Service Bulletin

SUBJECT: Large Cuber Wiring

Number: 2026-04.16
Product: 48" CIM
Date Issued: 4/16/2026
From: Technical Service

Figure 1: Incorrect Wiring

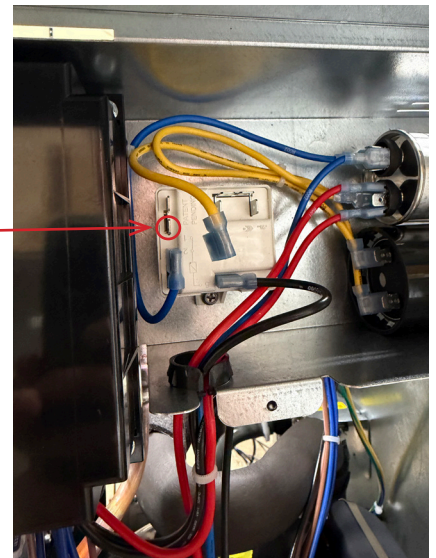
48" wide CIM Model Ice Machines starting with March serial numbers (2603XXXXXXXXXX - 2604XXXXXXXXXX) must have the potential relay wiring inspected upon start-up. See Figure 1.

If this condition is found, reconnect the yellow wire coming from the 01 terminal on the start capacitor to the number 1 terminal on the Potential relay. See Figure 2
